Groundwater Application Review Summary Form

Application # G- 19479

GW Reviewer Gabriela Ferreira Date Review Completed: January 2, 2025

A. GENERAL INFORMATION: Applicant's Name: Colton School District #53 County: Clackamas

Well Location Map

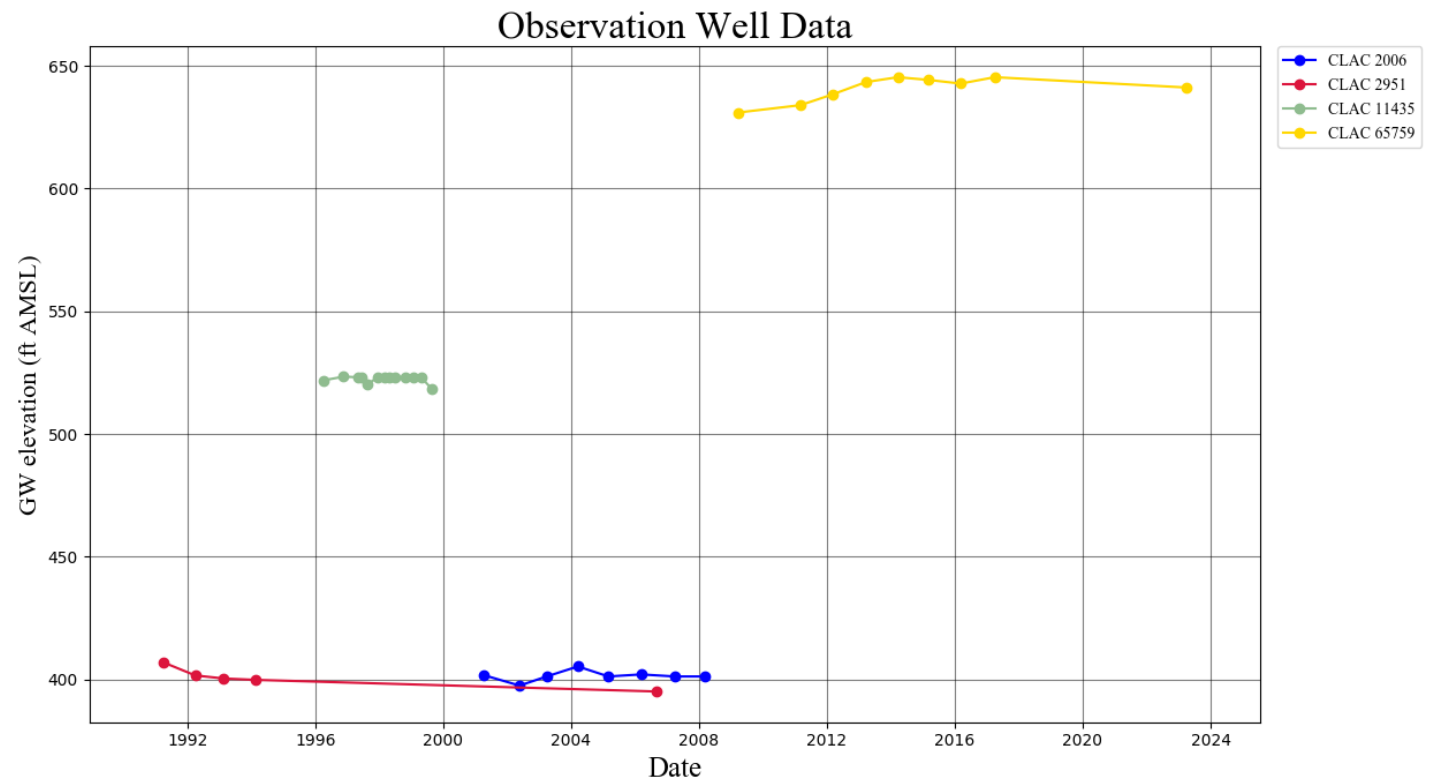
A4. **Comments:** The proposed POAs/POU are located approximately 0.5 miles southeast of Colton and 9 miles southwest of Estacada. The applicant proposes irrigation use on 36.1 acres by two wells to be constructed, for a maximum instantaneous rate of 0.089 cfs (~40 gpm) and maximum annual volume of 43.3 acre-feet.

Water-Level Measurements in Nearby Wells

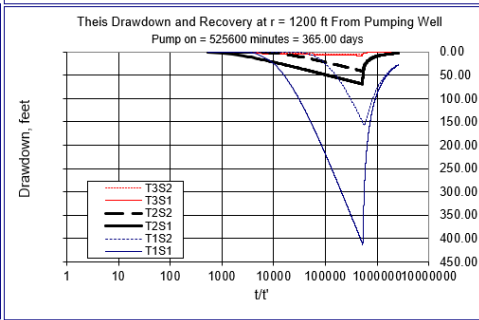
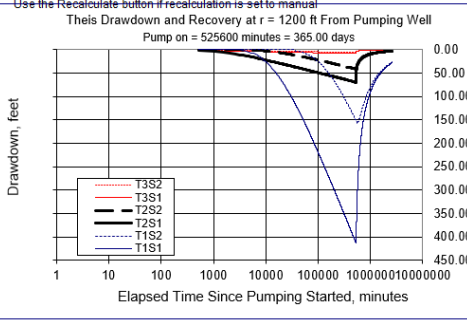
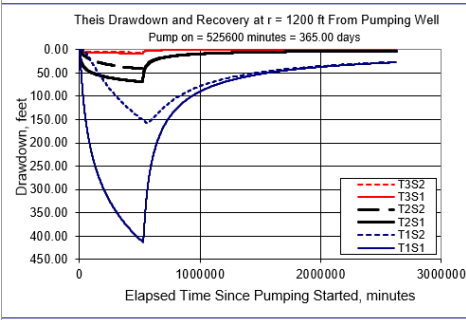
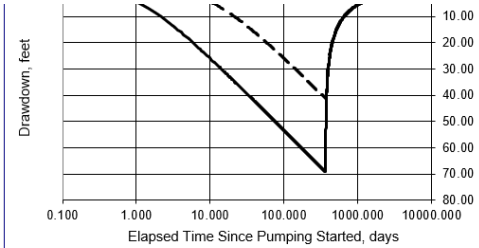
Water level data from four wells were selected for evaluation based on location and aquifer system. Two wells, CLAC 65759 (~1.5 mile west) and CLAC 11435 (~2 miles northwest), are near the western margin of the Sardine Formation and may be interlayered with the Troutdale Formation. The other two wells, CLAC 206 and CLAC 2951, are located approximately 8 miles north and likely produce from the Sardine Formation, although these wells may also have some hydraulic connection to the Clackamas River. CLAC 2951 reports a decline of approximately 12 feet from ~1991 to 2006; the other three wells have relatively stable water levels, with 10 to 15 feet of variability observed over the available record. Although somewhat limited, the available groundwater level data suggests that groundwater for the proposed use is not over appropriated.

Permit condition 7RLN is recommended to assess potential future injury concerns, and as a means to monitor long-term groundwater conditions in this area.
